REMARKS/ARGUMENTS

Appl. No. 10/605,481
Amdt. Dated November 10, 2004
Reply to Office action of September 08, 2004

Amendments to the Drawings:

Fig. 5

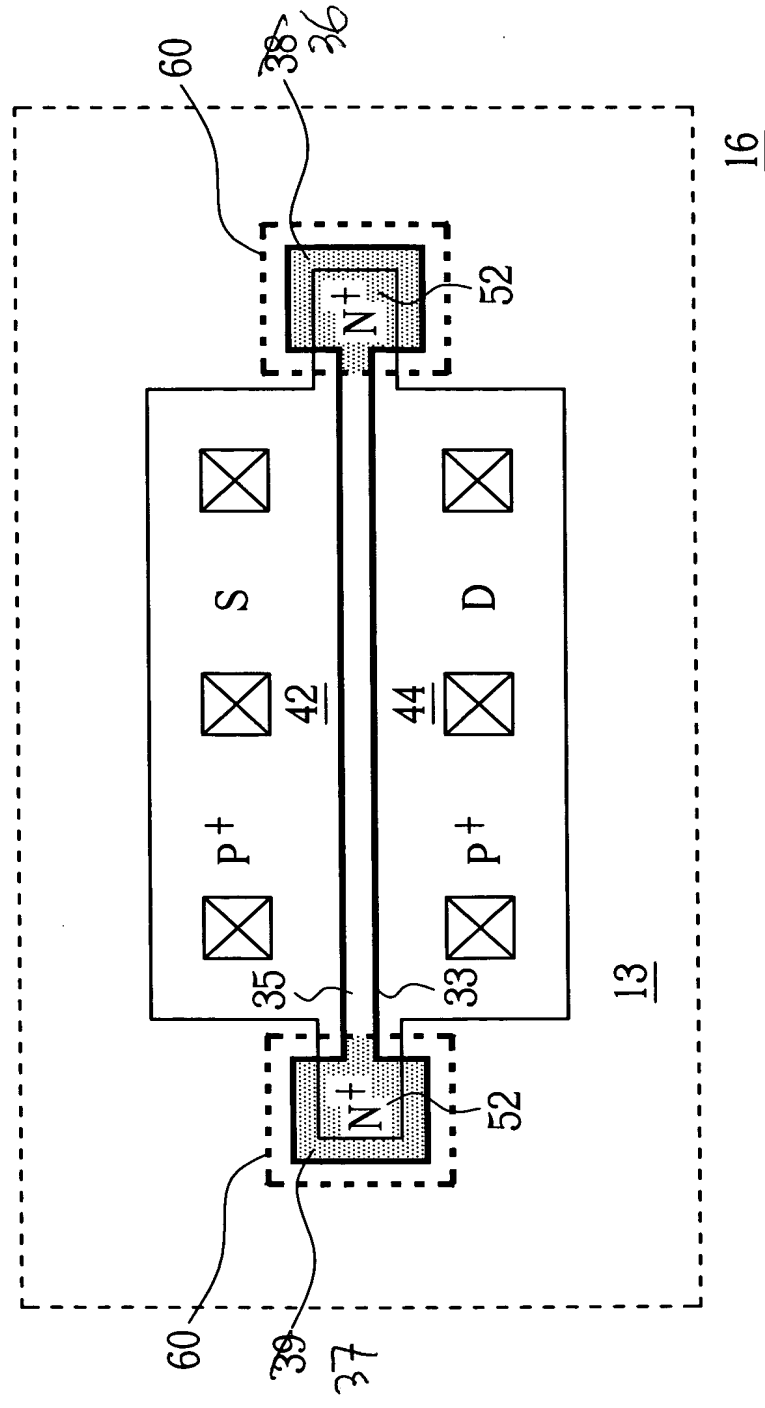
The drawings were objected to because element 37 mentioned in the description is not included in the drawings. In reply to this, two replacement sheets have been respectfully resubmitted, wherein in figure 5, the wrong reference signs 38 and 39 have
10 been replaced with the reference signs 36 and 37, respectively. Reconsideration of newly submitted Fig.5 is politely requested.
